ADDENDUM NO. 2
TO THE CONTRACT DOCUMENTS

Date: May 12, 2021
Jacobs Project No.: D3403200

for the
Crestview WWTP Solids Handling Improvements

JACOBS
ELECTRICAL
**DEWATERING BUILDING
POWER PLAN**

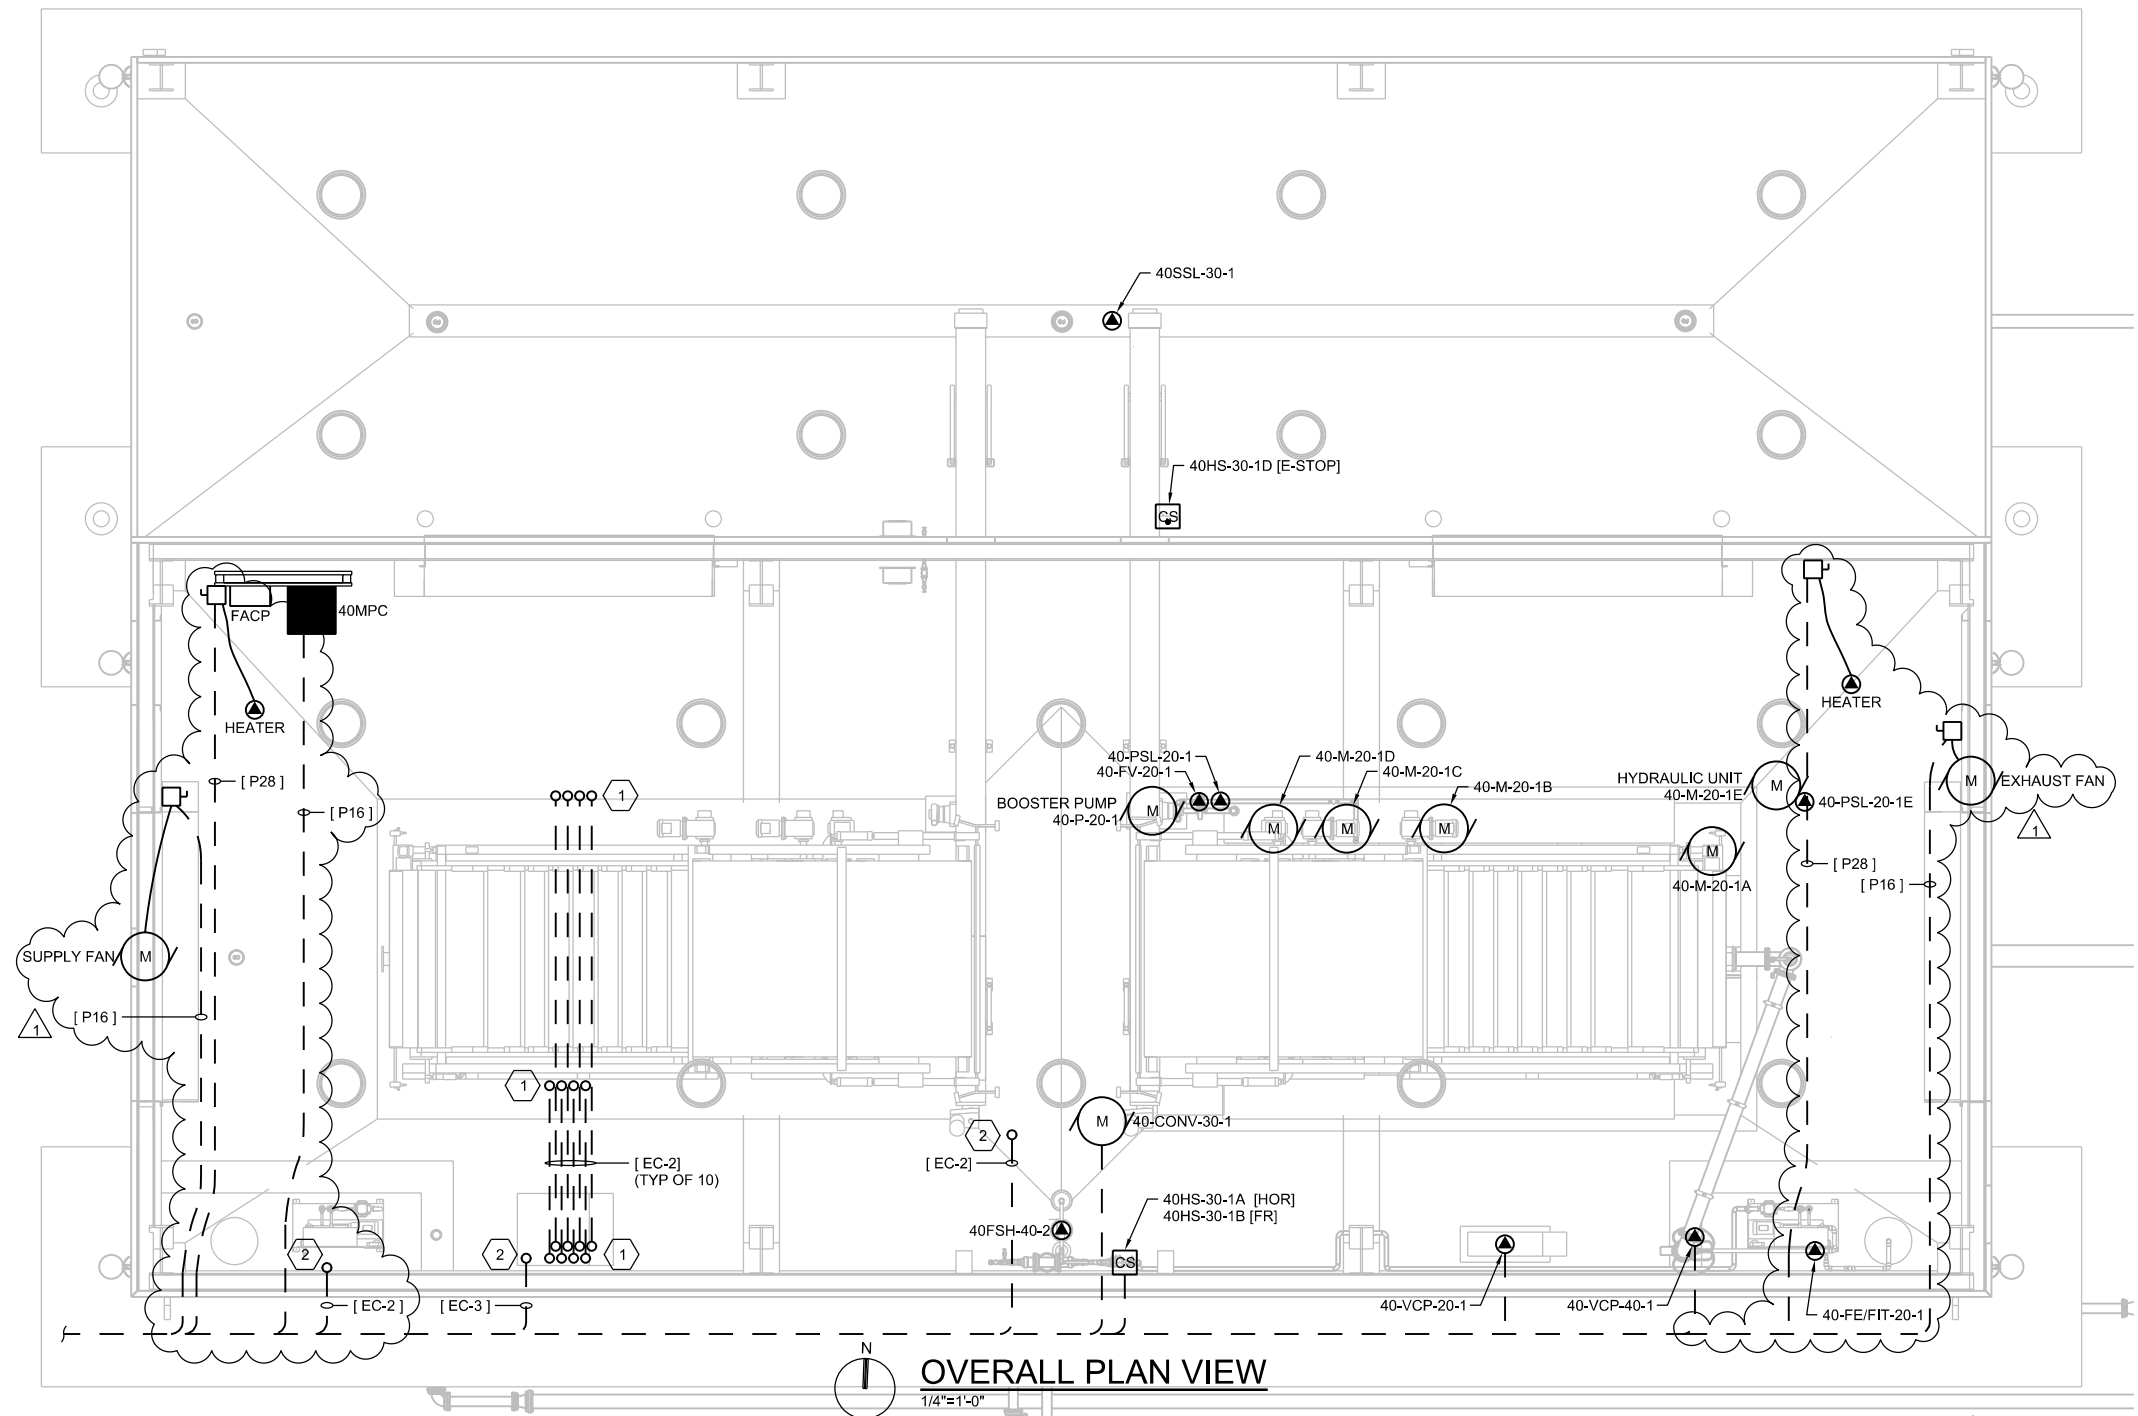
"4. Mount mixer TJB and disconnect switch a minimum of 24" off basin wall and outside of hazardous envelope."
 7. Drawing 40-D-2002, MOVE the hydraulic unit 40-M-20-1E adjacent to the belt press towards the northeast corner of the belt press. Coordinate final location with Owner and Engineer.
 8. Drawing 40-E-2002, DELETE and REPLACE in its entirety with the revised Drawing 40-E-2002 attached.
 9. Drawing 90-E-2001, ADD call out [C40] and [A4] for conduits between MCC-C4 and CP-B.
 10. Drawing 96-E-6001, DELETE and REPLACE in its entirety with the revised Drawing 96-E-6001 attached.
 11. Drawing 96-E-6001, ADD 3way light switch in WP enclosure at each end of drive through to control Type B light fixtures.

12. Q: Drawing 40-E-2002, 40HS-30-1C and 40HS-20-1A device locations are not shown.

R: These I&C tags represent the emergency stop pull cords for the screw conveyor and belt filter press which are located along the length of each unit. See Drawing 40-D-3002 for the general location of 40HS-30-1C. Coordinate with equipment manufacturers for wiring connection locations.

MCC ONE-LINE DIAGRAM AND FRONT ELEVATION

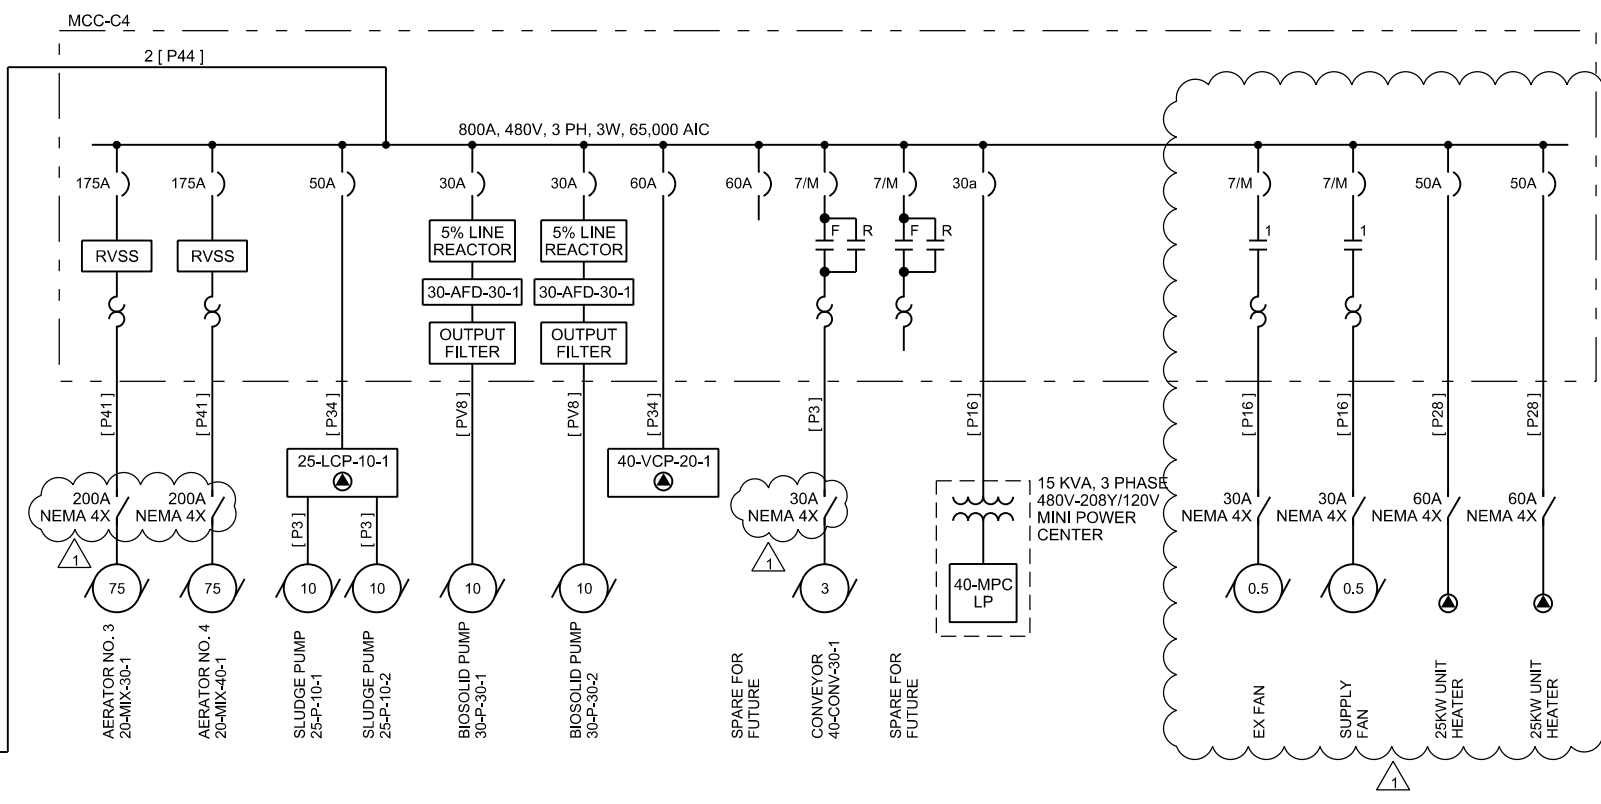
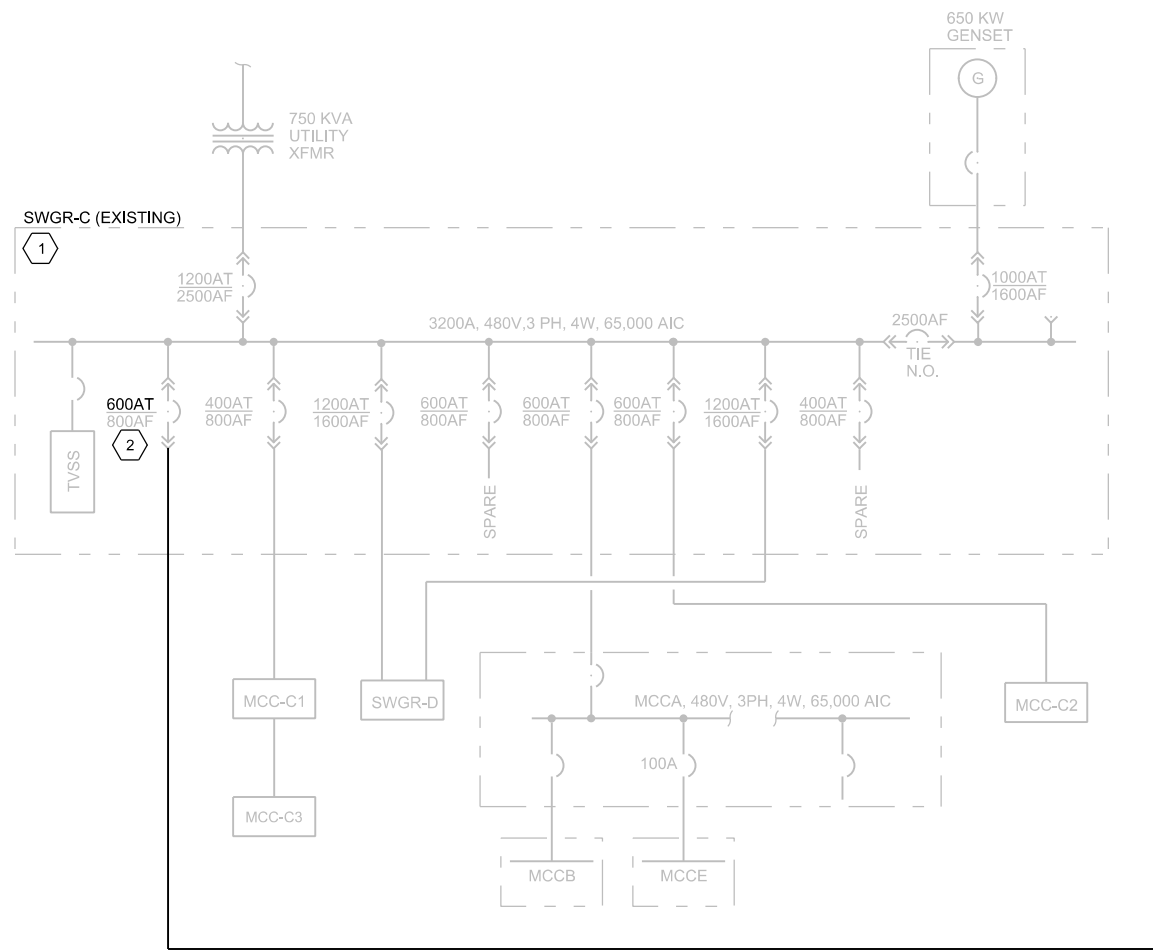
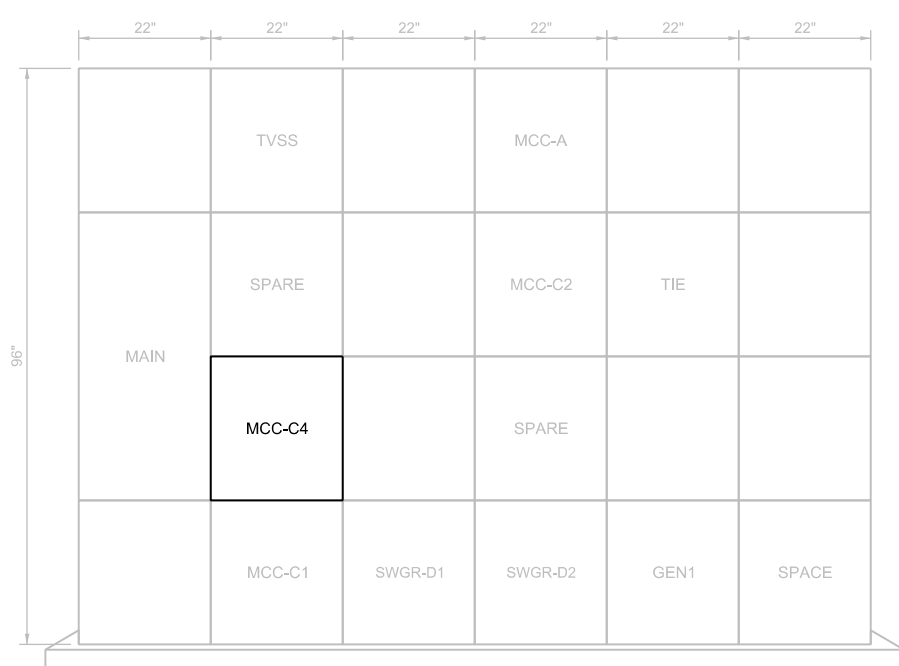
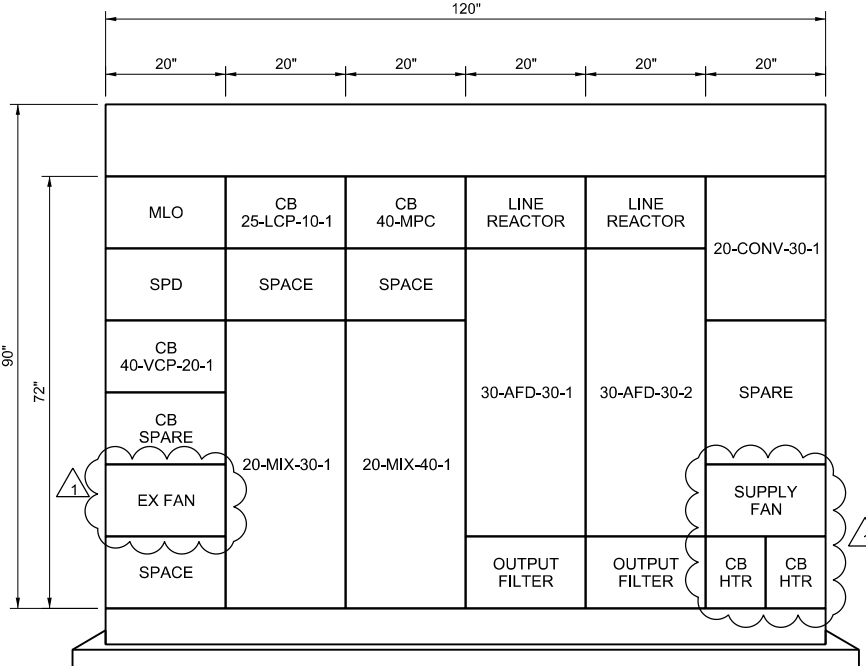
10. Q: Drawing 96-E-6001 calls for (2) 10KW unit heaters while 40-M-2001 is calling for 25KW units. Which is correct?

R: 25KW, see revised drawings attached herein.
